STATE OF RHODE ISLAND AND PROVIDENCE PLANTATION
DEPARTMENT OF TRANSPORTATION
RHODE ISLAND CONTRACT NO.2012-CH-010
FEDERAL-AID PROJECT NO. FAP Nos: HPP-4868(002)

Northwest Bike Trail / Woonasquatucket River Bikeway C-4

NOTICE TO PROSPECTIVE BIDDERS

ADDENDUM NO. 2 Prospective bidders and all concerned are hereby notified of the following changes in the Plans, Specifications, Proposal and Distribution of Quantities for this contract. These changes shall be incorporated in the Plans, Specifications, Proposal and Distribution of Quantities, and shall become an integral part of the Contract Documents.

CODE 901.9906 - PVC POST SLEEVE

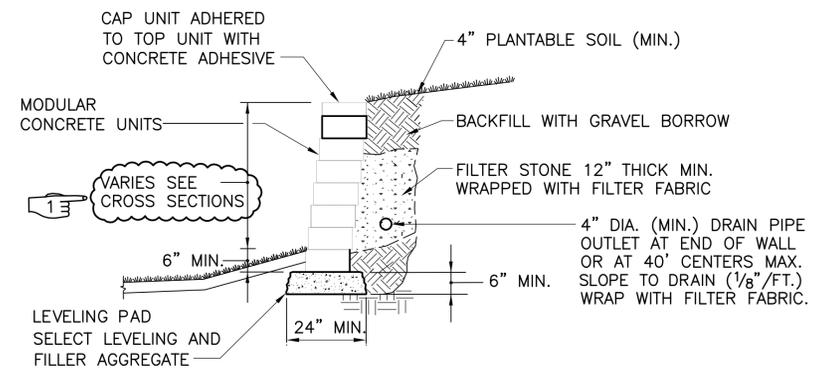
DELETE page JS-ii(R-1) in its entirety and REPLACE it with revised page JS-ii(R-2) attached to this Addendum No. 2. Item Code 901.9906 (Concrete Post) has been revised to PVC Post Sleeve.

DESCRIPTION: The work will consist of furnishing and installing wood rail post sleeves to accept the 6" x 6" wood rail fence posts in areas adjacent to reinforced and non-reinforced modular retaining walls to avoid damage to modular wall reinforcing fabric caused by driving fence posts.

MATERIALS: PVC pipe shall be Schedule 80 according to ASTM D1785.

Controlled low strength material (CLSM) shall be in accordance with Section 603 of the Rhode Island Standard Specifications and shall be Type IV.

CONSTRUCTION METHODS: PVC Post Sleeve shall be set plumb in dug holes adjacent to the modular walls. Sleeves shall be set at each location of fence post to avoid damage to the modular wall reinforcing fabric. PVC pipe shall be installed in such a manner to avoid compromising the reinforcing fabric supporting the modular walls. Sleeves shall be set at approximately two inches below finished grade to a depth equal to the wood rail posts and backfilled with controlled low strength material to the top of PVC pipe.

Install PVC post sleeves at five feet on center to accept wood rail fence posts.

MODULAR RETAINING WALL
TYPICAL FENCE POST DETAIL
 NOT TO SCALE

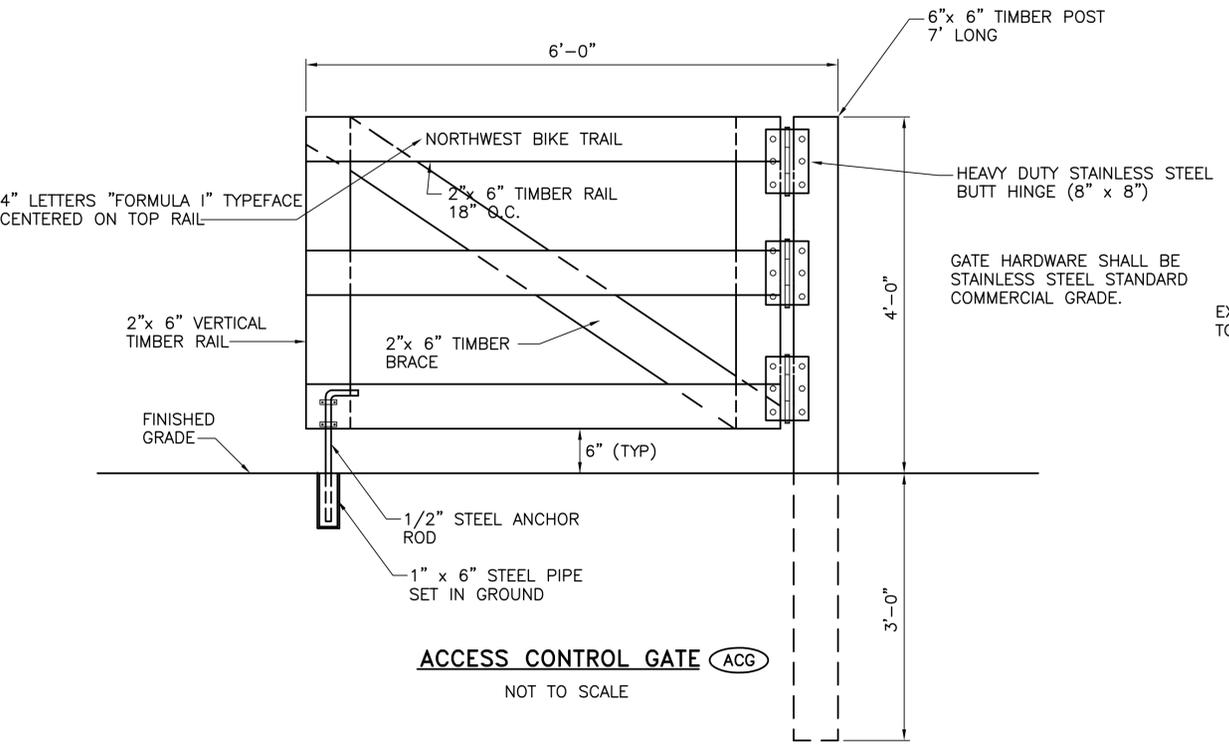
DELETE Details Part 1, Sheet 21 of 55(R-1) in its entirety and REPLACE it with Sheet 21 of 55 (R-2) attached to this Addendum No. 2. Revised Modular Retaining Wall Typical Fence Post Detail to replace concrete sleeve with a PVC sleeve.

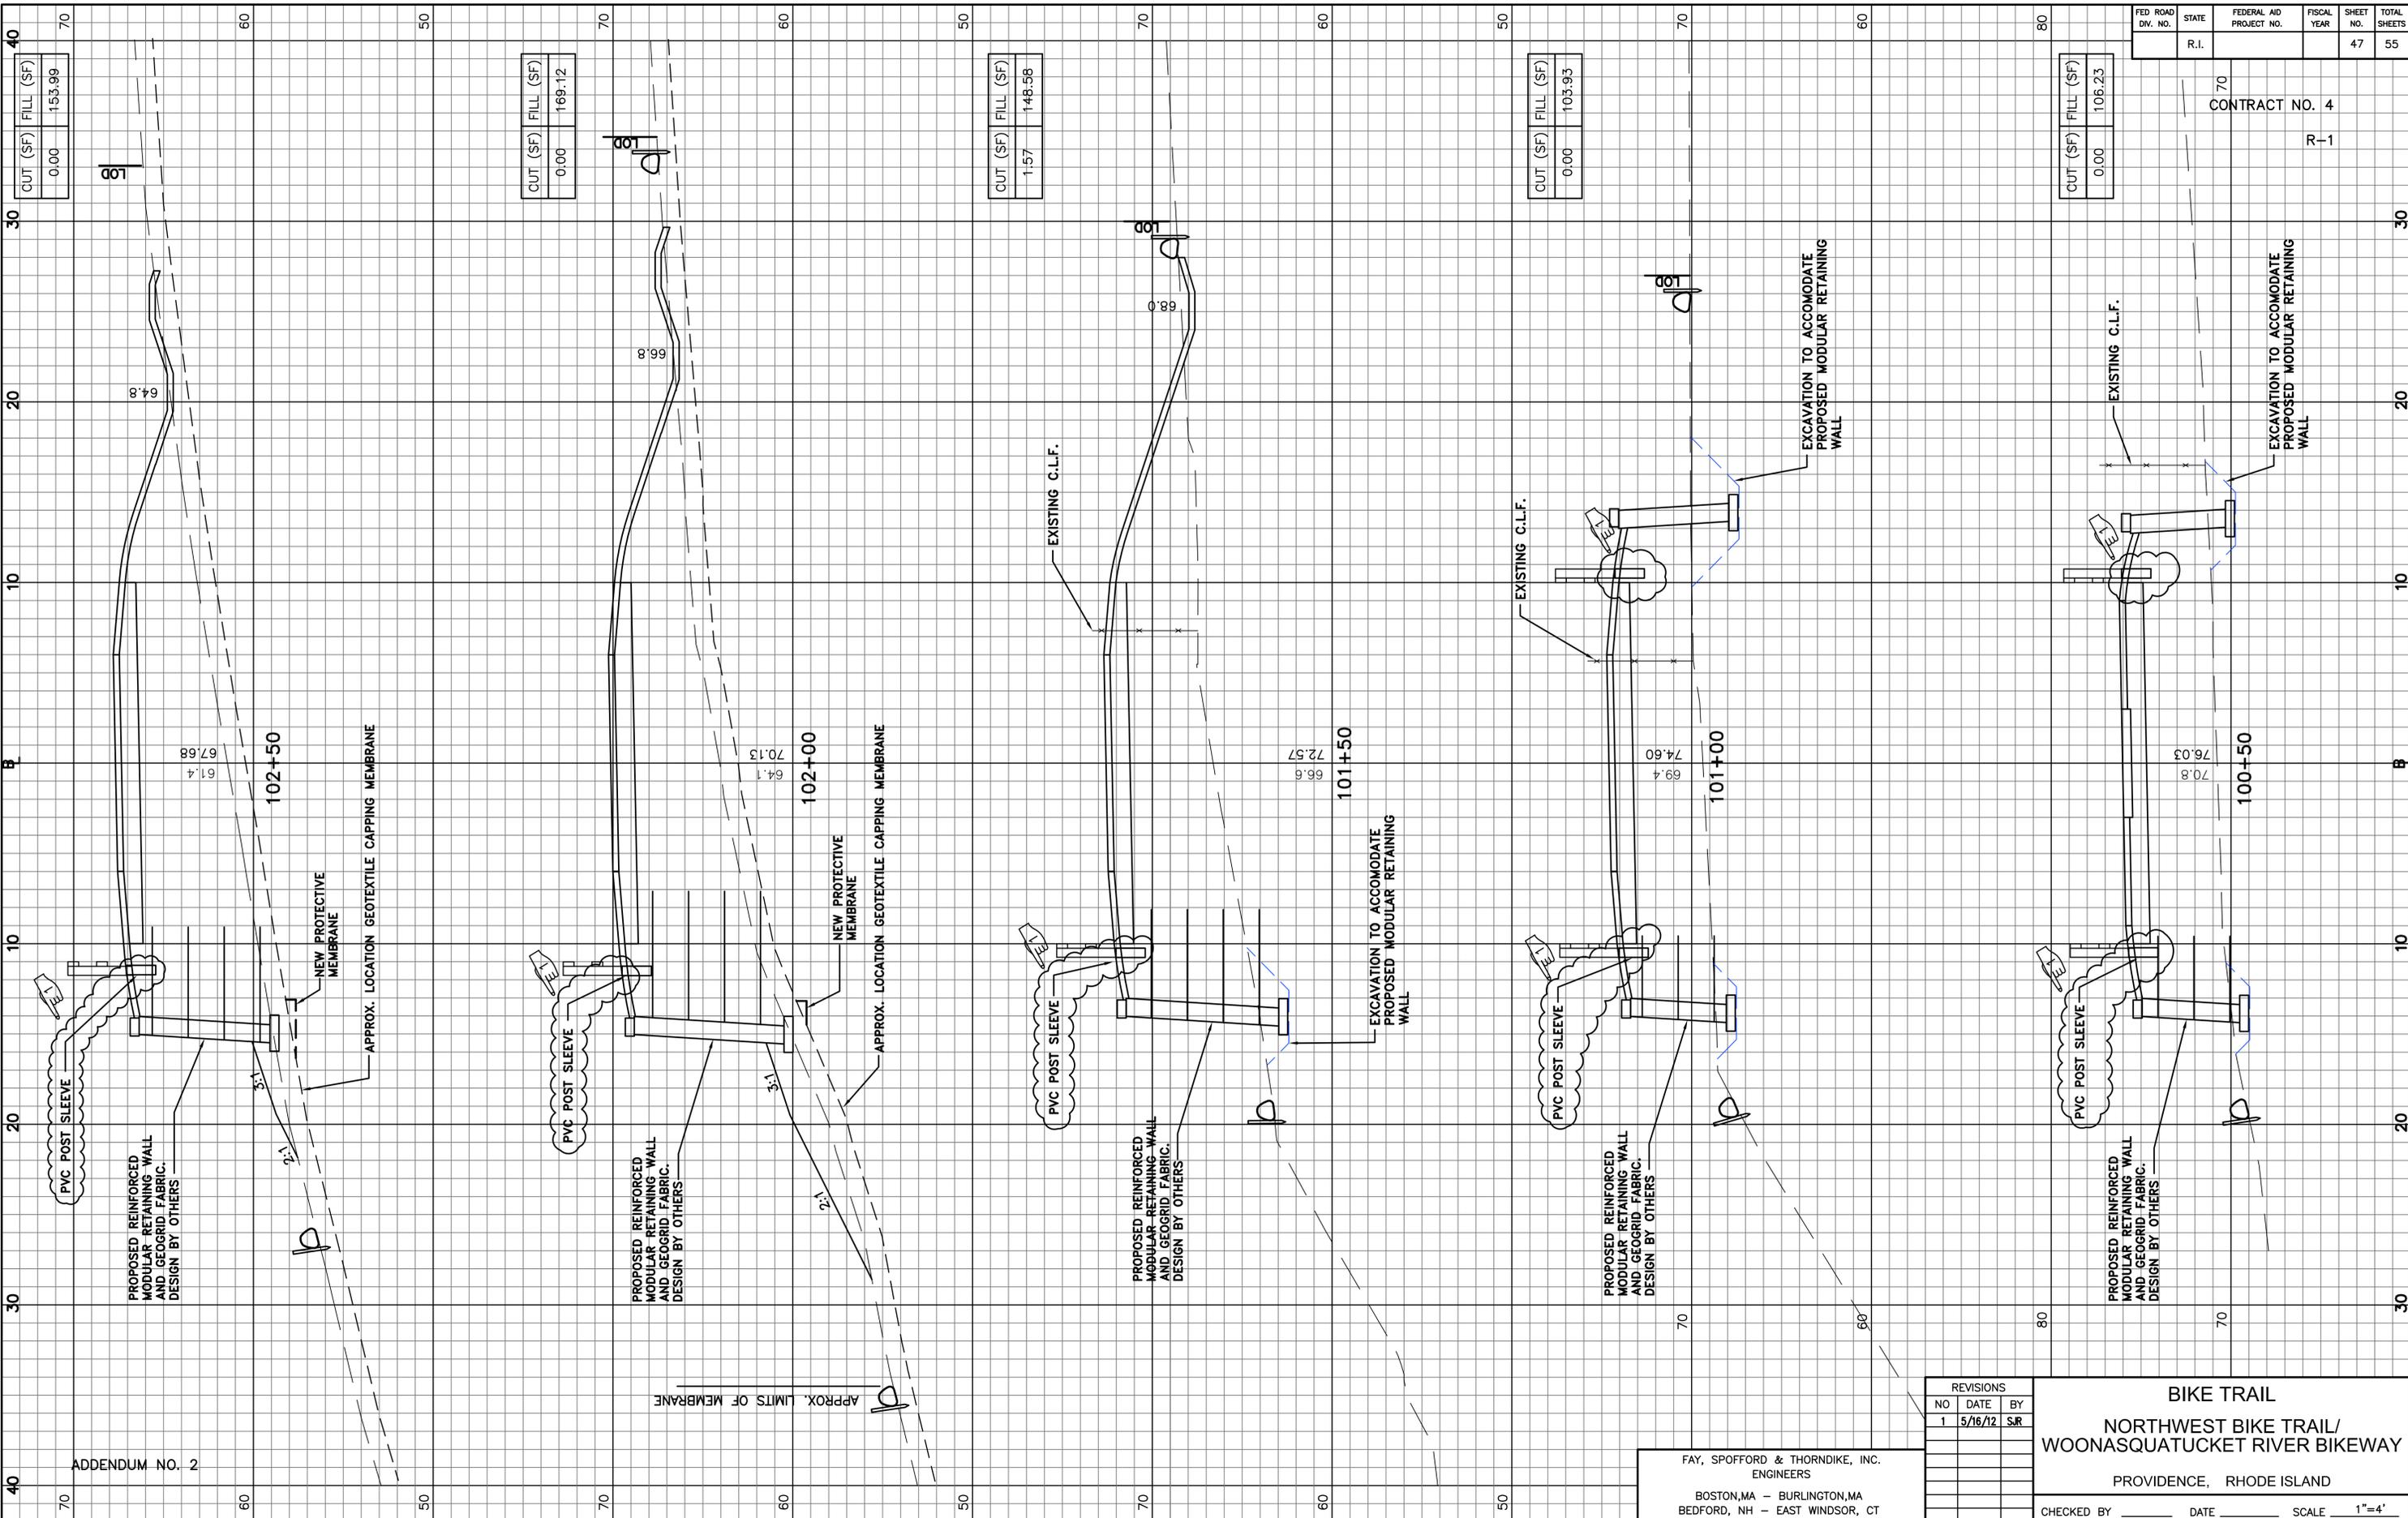
DELETE Cross Section, Sheet 47 of 55 in its entirety and REPLACE it with Sheet 47 of 55 (R-1) attached to this Addendum No. 2. Revised Concrete Post Sleeve to PVC Post Sleeve.

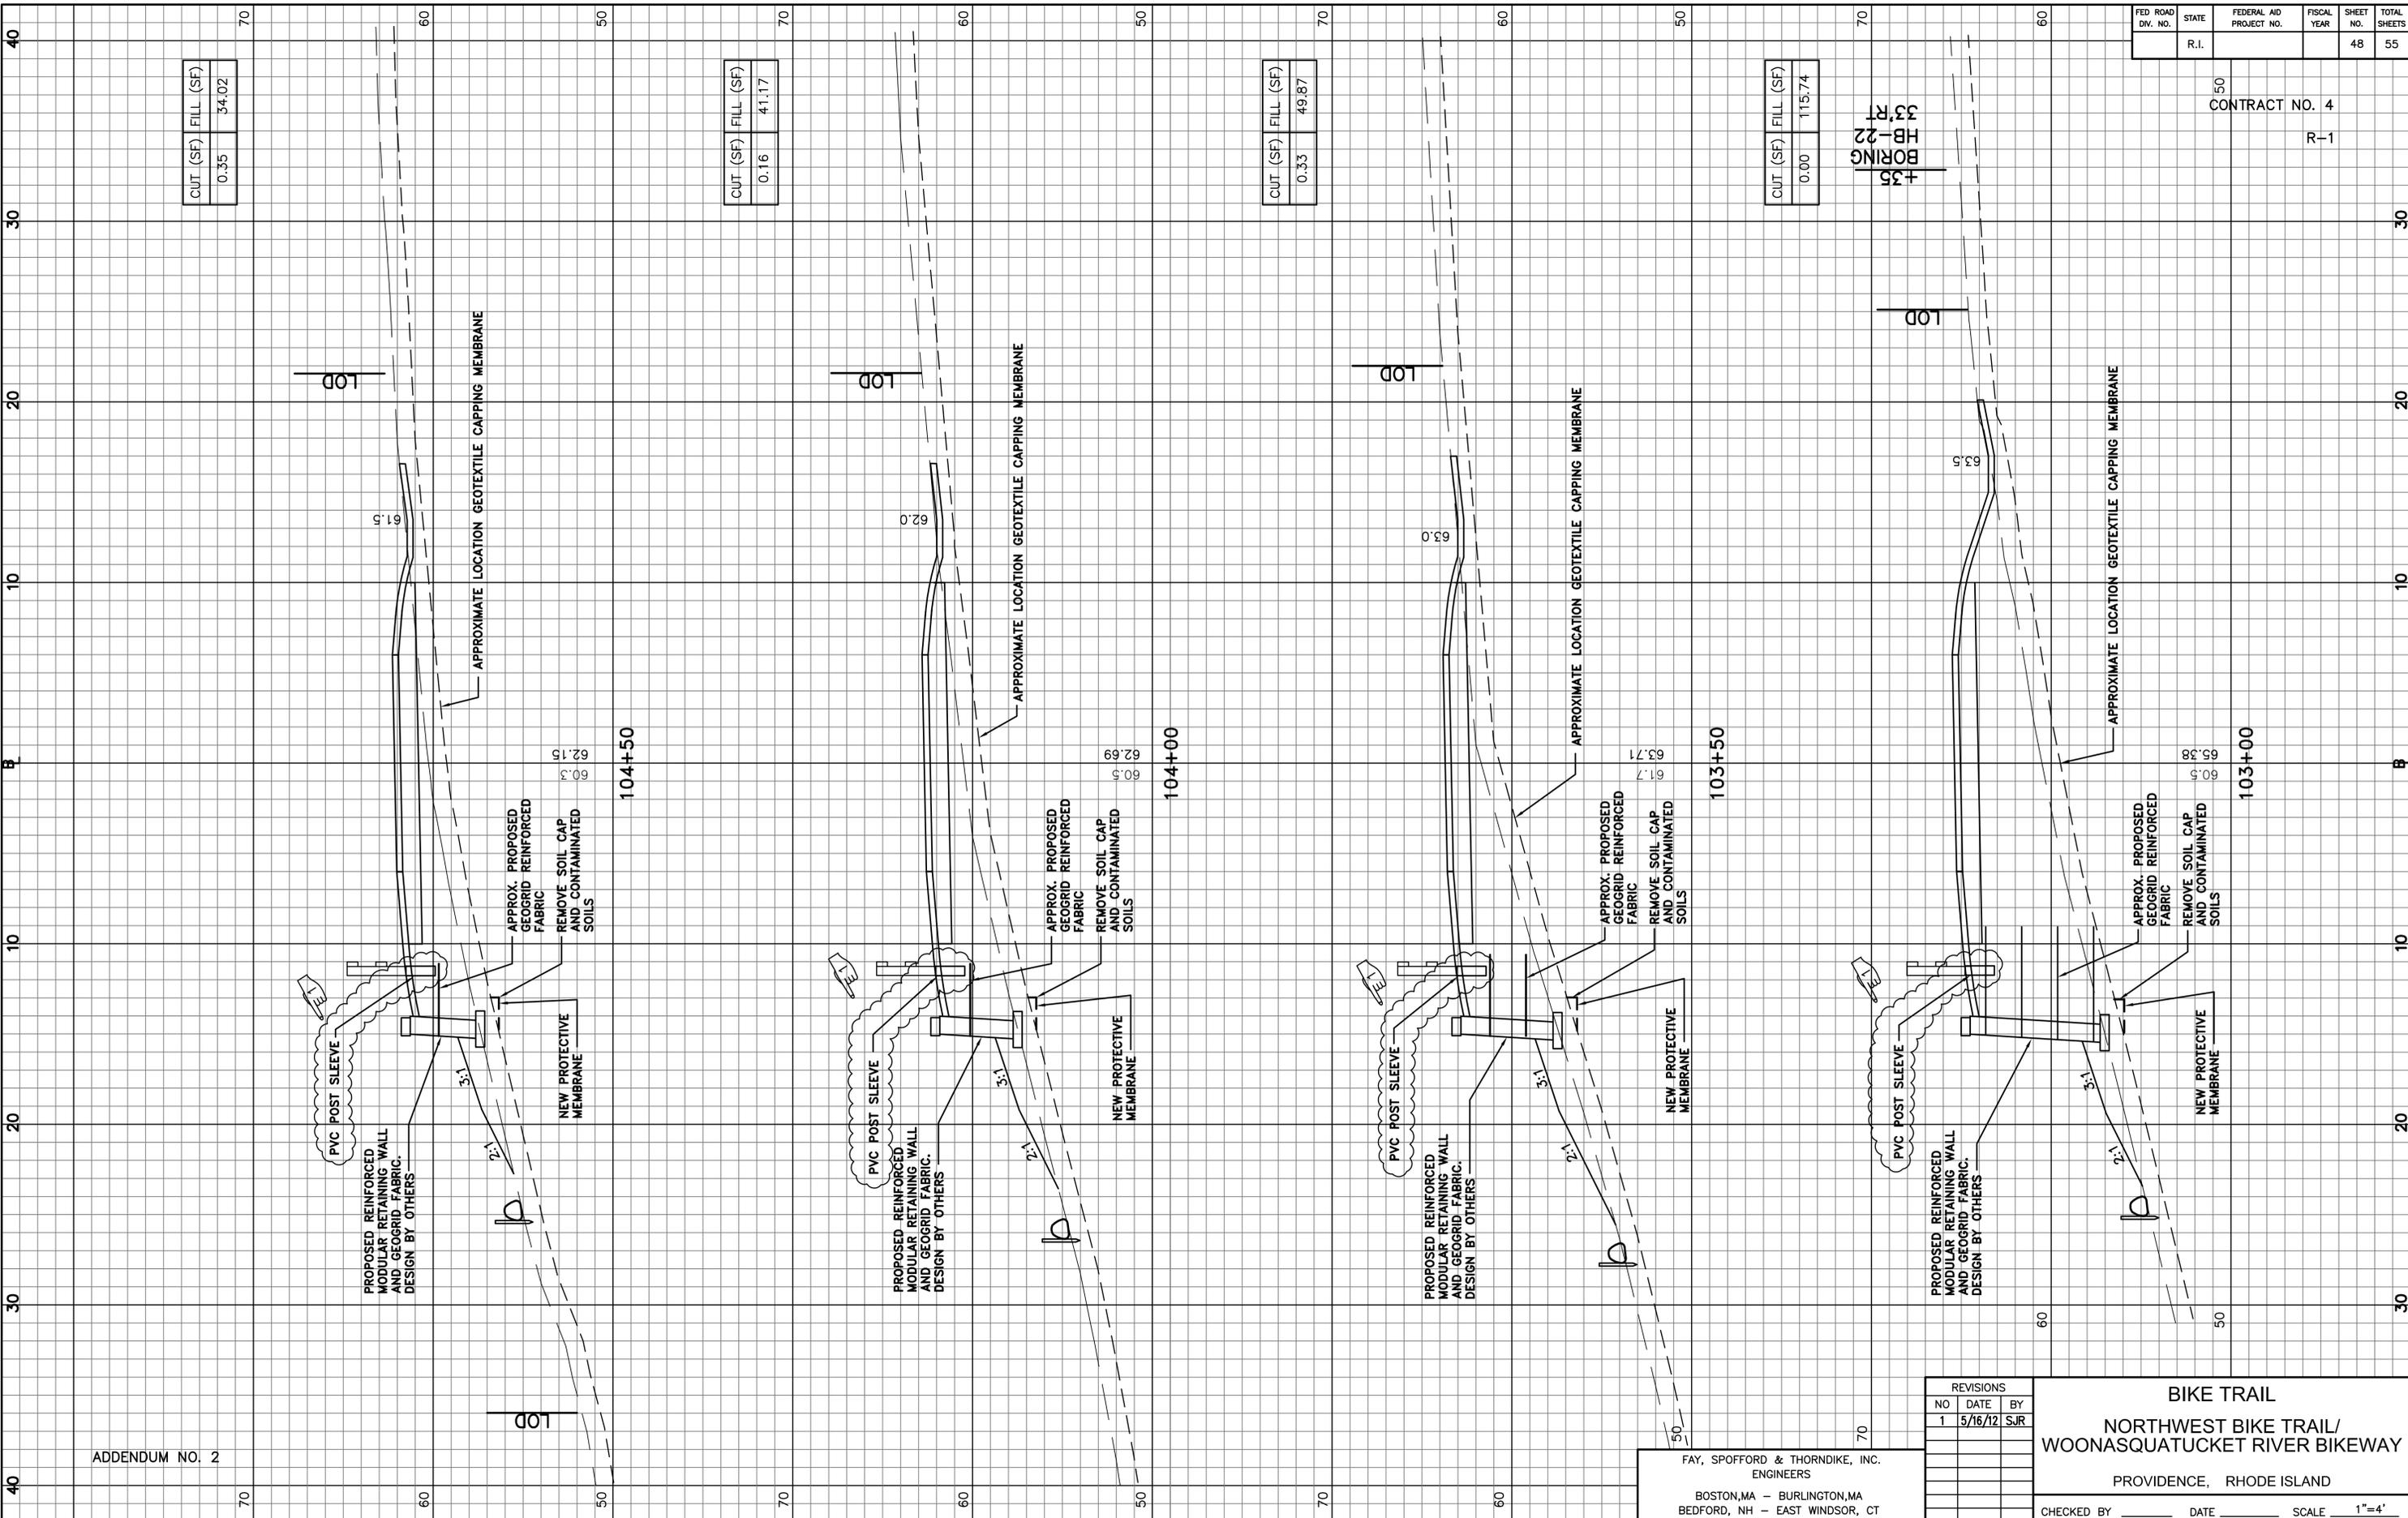
DELETE Cross Section, Sheet 48 of 55 in its entirety and REPLACE it with Sheet 48 of 55 (R-1) attached to this Addendum No. 2. Revised Concrete Post Sleeve to PVC Post Sleeve.
